ENGINE - FUEL AND CONTROL - FUEL METERING UNIT - INTRODUCTION OF REVISED PUSH ROD SEAL  
AND BEARING - PRESSURE RAISING AND OVERSPEED VALVES - CATEGORY CODE 4 -  
MOD.ENG-73-0057

V2500-ENG-73-0057

Location of fuel metering unit (FMU)  
Fig.1

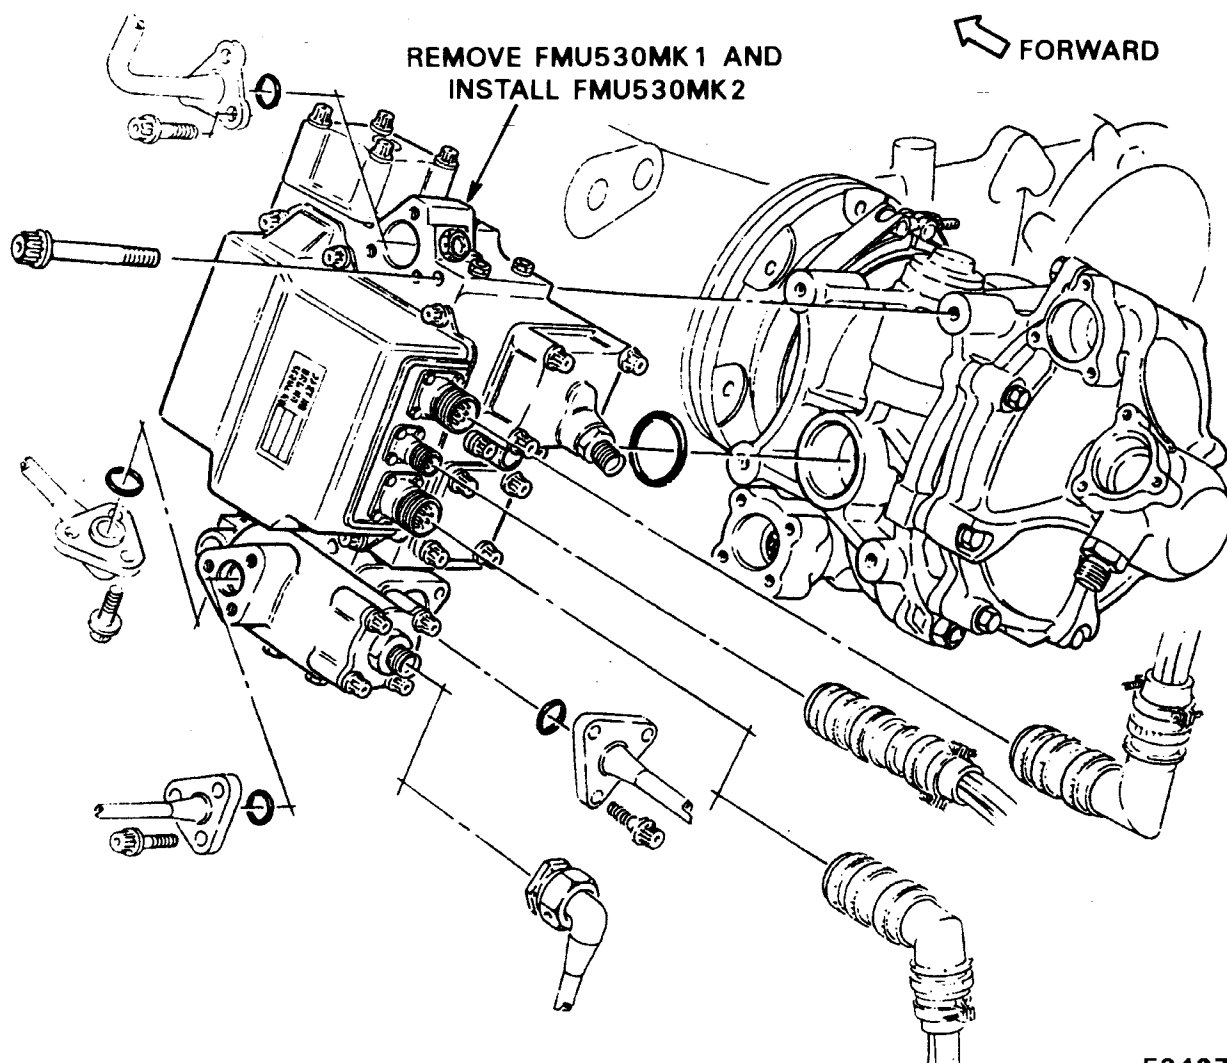
- (1) Remove the FMU 530 MK 1 fuel metering unit with instructions given in the A320 Aircraft Maintenance Manual or the A321 Aircraft Maintenance Manual, TASK 73-22-52-000-010-A01 or -B01, or the MD-90 Aircraft Maintenance Manual 73-21-52 Page Block 401.
- (2) Install the FMU 530 MK 2 fuel metering unit with instructions given in the A320 Aircraft Maintenance Manual or the A321 Aircraft Maintenance Manual, TASK 73-22-52-400-010-A01 or -B01, or the MD-90 Aircraft Maintenance Manual 73-21-52 Page Block 401.
